From: Emma Macari <emacari@SDUBLINCOCO.ie>
Sent: Wednesday 15 July 2026 14:54
To: Lauren Griffin <lauren.griffin@pleanala.ie>
Subject: ACP-324264-26 St Edmundsbury Hospital Lucan Road Lucan Co Dublin - SDCC Response

**CHIEF EXECUTIVE'S REPORT ON PROPOSED STRATEGIC
INFRASTRUCTURE DEVELOPMENT BY THE GOVERNORS OF ST. PATRICK'S
HOSPITAL FOR THE DEVELOPMENT OF A NEW MENTAL HEALTH HOSPITAL
FACILITY AT ST EDMUNDSBURY HOSPITAL, LUCAN ROAD, LUCAN, CO.
DUBLIN**

Figure 3: Figure 4-19: Encroachment of proposed works into pNHA woodland habitat (Source: Environmental Impact Assessment Report)

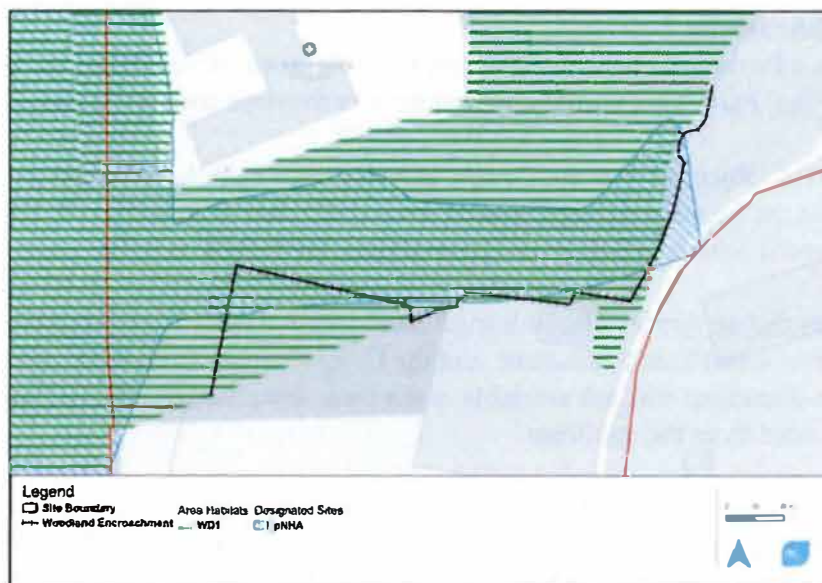
In relation to impacts of the proposed development on the pNHA, it is summarised in the Biodiversity Chapter of the EIAR that there would be *'irreversible permanent habitat loss'* and *'part of the woodland associated with Liffey Valley pNHA will be cleared and become an artificial building and surfaces, this will result in a permanent alteration of the Liffey Valley pNHA, reducing the overall woodland cover of the pNHA by roughly 1500m²'*. This report also states that there is a required clearance and maintenance 5m buffer around the building.

To address this, mitigation measures are proposed by the applicant, which include a pNHA Woodland Relocation. The appropriateness of the proposed mitigation measures is discussed further below by the Heritage Officer and Parks and Public Realm Department.

As a result, the report makes recommendations for the proposed design to be amended in order to remove the intrusion of the north-western corner of the proposed development into the regenerate woodland buffer and pNHA woodland. Additionally, the Heritage Officer report makes recommendations for the submission of a Biodiversity Management Plan, the retention and protection of existing trees and hedgerows, a more detailed assessment of potential impacts on bats and additional bat survey work and clarification is recommended to be sought from NPWS regarding the appropriate process for the application of derogation licences to disturb protected species.

Figure 1 proposed layout at the junction at Chapel Hill.

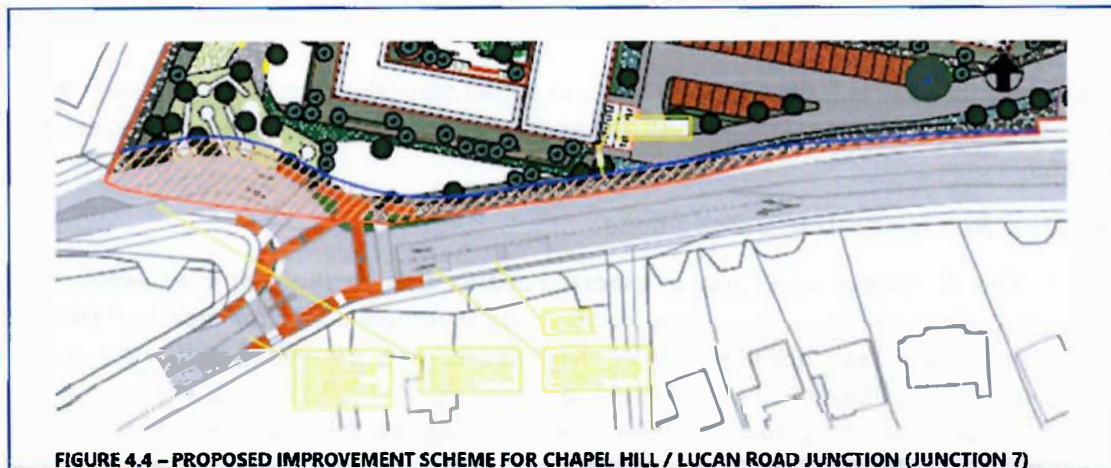
The primary access is from the Lucan Road R835. The existing road is a 9.5m wide carriage way with good pedestrian facilities on both sides. The speed limit is 50km/h and there is a weight restriction of 7.5 tonnes. There is a centre median to allow right turning into an existing access and the St Andrew's School. A bus lane begins 60m west of the entrance.

Figure 2 Access Junction.

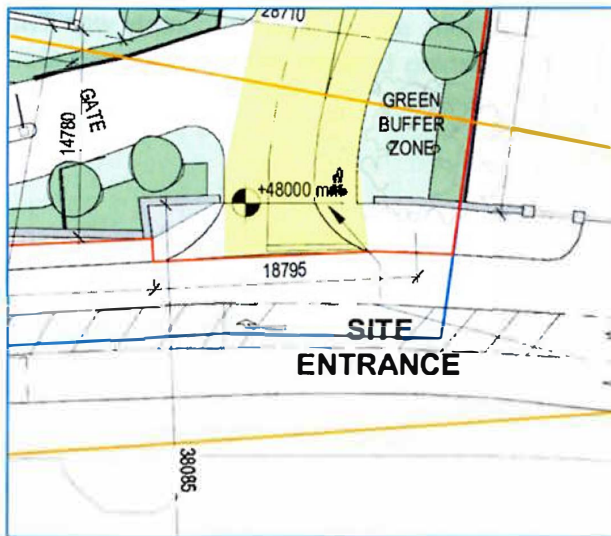
The existing access to the hospital will be altered with new corner radii and overall width. The existing access is 5.717m wide. The proposed access will be 6.5m for vehicles and a 3.0m walking path. The overall access will be excessive at above 11.0m particularly for pedestrians to cross. The design should prioritise pedestrians and should conform to DMURS standards for corner radii and pedestrian crossing. The boundary walls at the access will be kept at the original height of 1.66m.

There is a right turning arrow for vehicles entering the development, but there is no direction or line marking for vehicles exiting and wanting to turn right. The access is very close to the entrance to the school at 20.0m. There should be adequate visibility splays in both directions considering the low speeds of the R835, but the applicant should provide the vision lines on a layout. There are proposals to move the bus stop closer to the Chapel Hill Junction, the applicant shall consult with the TII on the best possible location for the bus stop. The current proposal is too close to the traffic lights and may result in reckless overtaking at the junction by drivers.

The main access road is 6.0m wide and leads to a staff carpark to the left when entering and straight on to visitor parking. The parking and access arrangements should be assessed by a road safety audit.
